SPECIALIST SUPPLEMENTARY COMMENT ON POSSIBLE 385 METRE EXTENSION OF 22 KV TRANSMISSION LINE TO BLOUPUTS SUBSTATION

Letter requesting comment from specialists

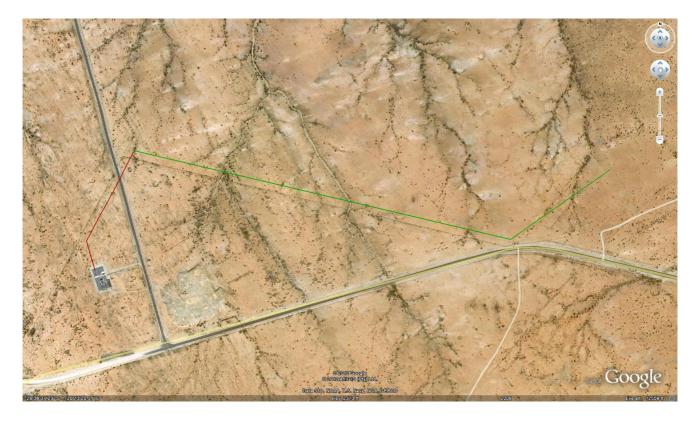
While the transmission line does appear to cross some drainage lines, it should not present any issues providing the pylons / structures remain outside of the recommended 10m buffers for the drainage lines and that the other recommendations given for the project are also applied to the construction of the transmission line.

My understanding from your communication is that any issues relate only to the new section of power line, indicated in red in the figure sent to me and approximately 380 m in length.

From Google imagery, the new section of power line does not cross any drainage lines, except at its northern end where it connects to the existing power line. The potential impact of concern is therefore not serious from the point of view of the specialist study that I undertook. I do not foresee that any modification to my report is required. However, if any tower structure are to be placed within this drainage line, then a permit would be required

and any other recommendations in the specialist study should be adhered to.
